IN THE DRAWINGS

REMARKS

The present application was filed on January 5, 2004 with claims 1 through 42. Claims 1 through 42 are presently pending in the above-identified patent application. Claims 38-42 are proposed to be cancelled herein, without prejudice.

FIG. 2B
Prior Art

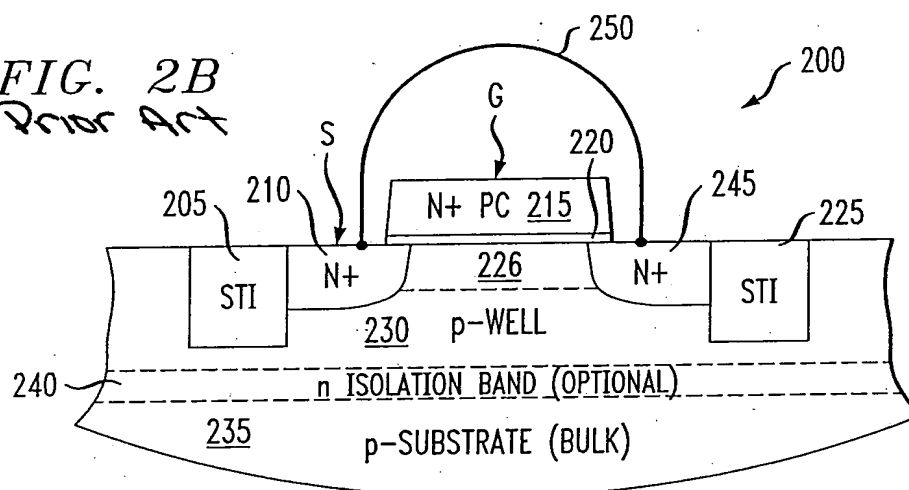
The Examiner has requested that a prior art label be added to Figures 1B, 2B, 4B, 5B, and 6-9. The Examiner has objected to the formal drawings, and requested that they be labeled as "Replacement Sheets." Applicant submits that Figs. 1A, 1B, 1C, 4A, 4B, 6 and 8 show a gated diode structure with only a gate and a source (and no drain). There are only two terminal areas for the gated diode. The present invention recognizes that this structure without the drain leads to significantly smaller gated diode physical structure (which keeps the area much smaller in applications such as memories and sense amplifiers). Thus, Figs. 1A, 1B, 1C, 4A, 4B, 6 and 8 are different from what is shown by the prior art, including Mead.

Please amend FIGS. 2B, 5B, 7 and 9, as indicated on the attached marked-up copy of original FIGS. 2B, 5B, 7 and 9, to include the label “prior art.” No new matter is introduced.

Applicants have labeled Figures 2B, 5B, 7 and 9 as "prior art" in accordance with the Examiner's suggestion and each sheet has been labeled as a "Replacement Sheet."

Applicants respectfully request entry of the amendment to FIGS. 2B, 5B, 7 and 9, as indicated on the attached marked-up copy of original FIGS. 2B, 5B, 7 and 9 submitted herewith for the Examiner's approval, and request that the objection to the drawings be withdrawn. No new matter has been introduced.
